CITY OF CODY
PLANNING, ZONING AND ADJUSTMENT BOARD
TUESDAY, JANUARY 13, 2015
CITY HALL COUNCIL CHAMBERS @ 12:00 NOON

MEETING DATE:	JANUARY 13, 2015	TYPE OF ACTION NEEDED	
AGENDA ITEM:		P&Z BOARD APPROVAL:	
SUBJECT:	REBEL ROW MINOR SUBDIVISION—A FOUR-LOT PRELIMINARY PLAT APPLICATION. SUB 2014-04	RECOMMENDATION TO COUNCIL:	X
PREPARED BY:	TODD STOWELL, CITY PLANNER	DISCUSSION ONLY:

RE: Rebel Row Minor Subdivision
Preliminary Plat Review

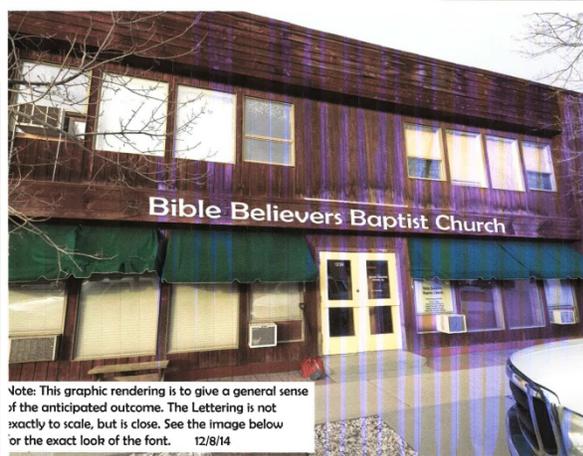
The sign type, location, and size meet the requirements for the D-2 sign district in which the property is located. (Note: While the property is in the downtown

The wall sign is proposed at approximately 26.7 square feet in size, where 150 square feet would be permitted. The sign will be created by individual letters mounted directly on the wall of the building. The sign will match the lettering of "The Thistle" sign, which store occupies the east ½ of the building.

The purpose of the Downtown Architectural District is understood to be the promotion of architectural compatibility and preservation of historic features. The sign is of professional quality and conservative in size, which is in character with the immediate area.

Approve the wall sign for the Bible Believers Baptist Church as proposed.

Preliminary Plat

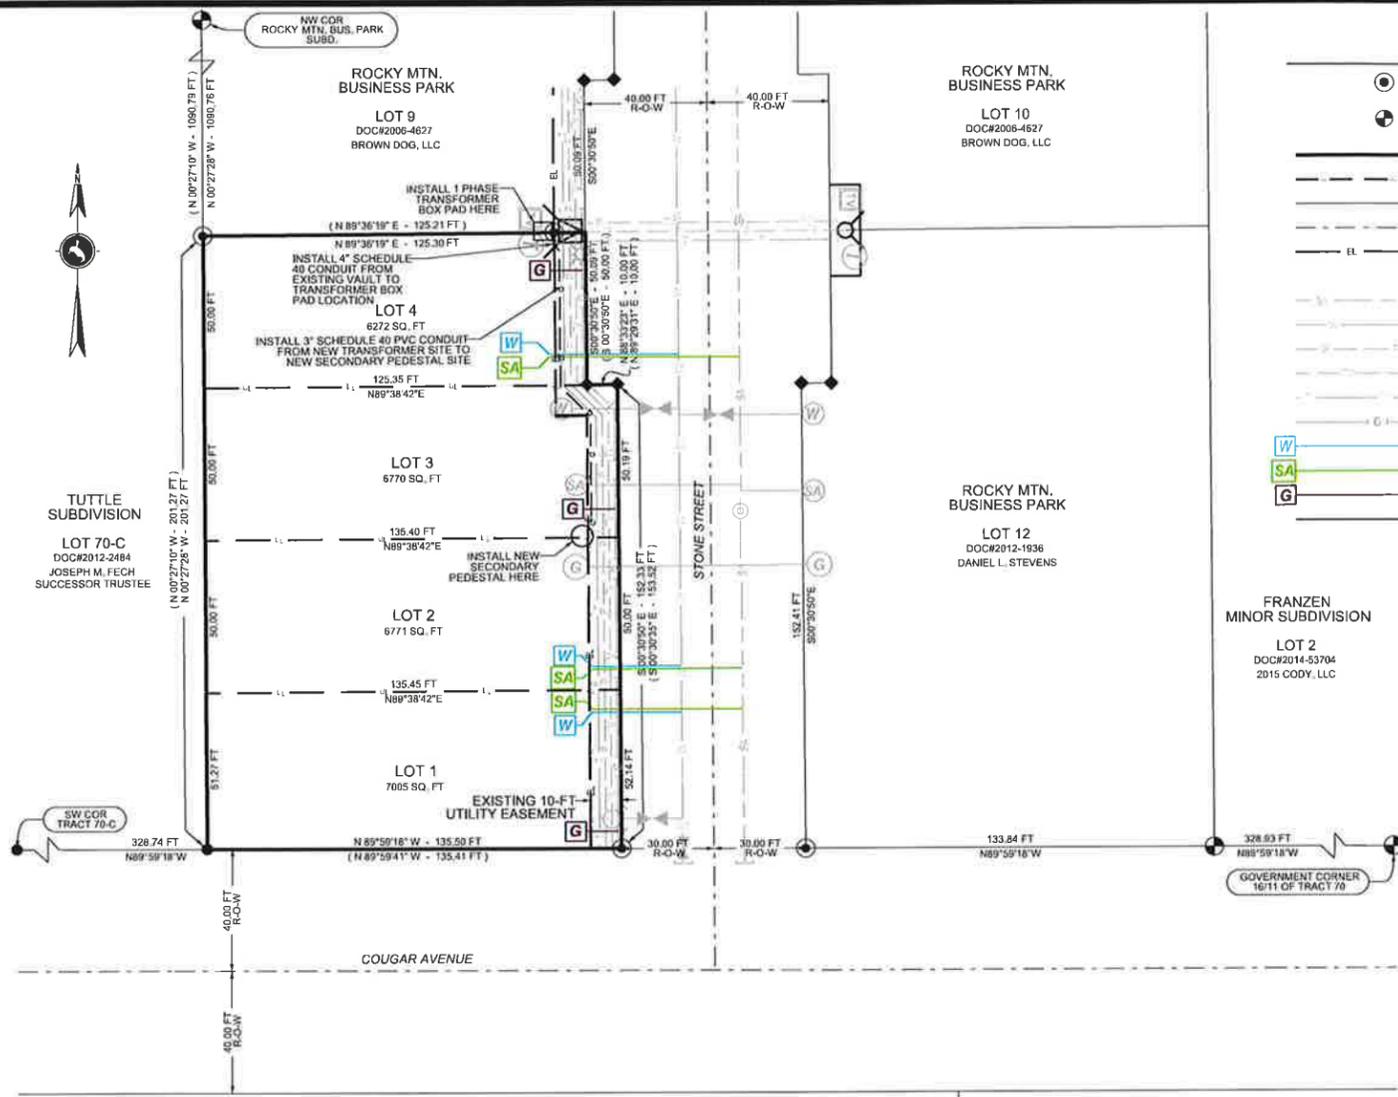
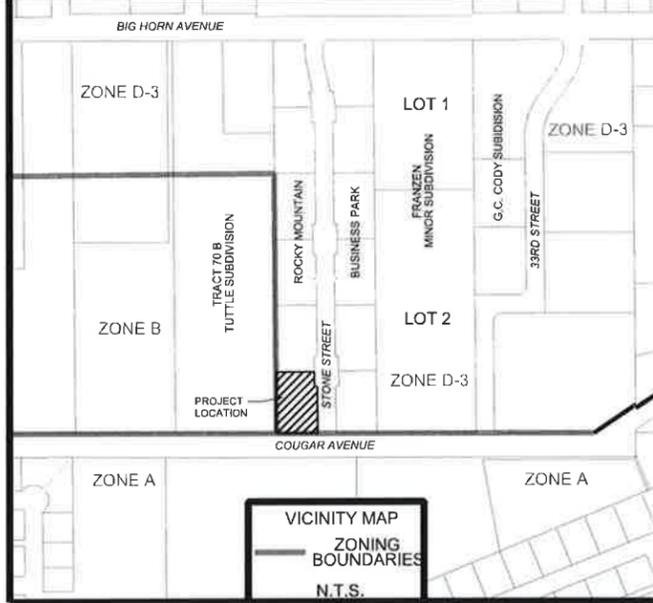
Corrections: The preliminary plat shows the gas line as the closest utility next to Stone Street, but it is physically located the furthest. Also, the certificate of dedication and recorder's acceptance are not necessary on the preliminary plat. A corrected copy should be provided for the council review.

1. The combined frontage of Lots 1-3 is shown as 152.46', yet the Rocky Mountain Business Park final plat shows 153.52'. Please correct, or note the distance of record as needed.

2. Please show the electrical system improvements for the new lots, as outlined by the city electrical superintendent. His comments and drawing are attached. If alterations to the plan are desired, please contact Bert Pond.

3. Please show or describe the sewer/water joint trench detail (minimum 12" horizontal and vertical separation, with sewer above water).

4. As access to Lot 4 will affect the storm water system for the Rocky Mountain Business Park, we need details of the planned access crossing and calculations verifying that adequate detention/infiltration will still be provided.

- Note on the plat the sizes of the proposed water services and sewer services.

- Note that sidewalk will be provided along Stone Street.

- Under "Notes", add note 3 from the Rocky Mountain Business Park plat.

- Under Note 4, "Existing Utilities", it is suggested that you add a note referring the reader to the Rocky Mountain Business Park as-builts.

9. Under requested variances, add “City Ordinance 11-4-2(Q). Waiver of construction of Cougar Avenue, subject to support of a future improvement district for construction of Cougar Avenue to City standards.”, or similar language.

10. The certificate of dedication need not be on the preliminary plat, but it notes “What’s Left, LLC” as the owner, while the County records still show “Brown Dog, LLC”. Please clarify the owner situation.

The distances have been corrected and the record distances noted. FYI, the distances shown on the Rocky Mountain Business Park plat are incorrect, and we plan to record an affidavit to correct the mistake.

The layout as proposed by the electrical superintendent is shown.

Detail has been added. However, as discussed, the water service will be higher than the sewer service.

A detail for the driveway has been added to the plat. As shown, the driveway for the north lot will cover 141 ft² of the percolation trench. This portion of the trench will be filled with subbase and base course beneath the drive, removing the storage volume of the cobble and the percolation area from the trench's overall disposal capability. The drainage design for Rocky Mountain Business Park required the cobble used for percolation/storage be three feet deep. Thus, the calculation for the volume of disposal capability lost (assuming 40% voids in the cobble) is 141 ft² x 3 ft x 0.40 = 169 ft³. The volume of percolation capability lost (assuming ¼ inch/minute perc rate) = 353 ft³. Therefore the total volume lost is 522 ft³. See table below.

It is proposed to deepen the remaining percolation trench to offset the volume lost due to the driveway. The remaining area of percolation trench from the north side of the driveway to the north lot line is 290 ft². Therefore 522 ft³ ÷ 290 ft² = 1.8 ft. The developer will deepen the remaining percolation trench by at least 1.8 ft.

Sizes added to the legend. Proposed water services are ¾ inch; proposed sewer services are 4 inch.

Because the exact development for the remaining lots north of Lot 11 is unknown, the developer proposes to install sidewalk along the four resulting lots in this subdivision. Pedestrian traffic north of these lots is minimal and sidewalk installed along the undeveloped lots will likely be required to be removed and replaced when future development occurs.

Note has been added.

Note has been added.

Variance request has been added.

Ownership will be transferred to What’s Left, LLC prior to completion of the final plat.
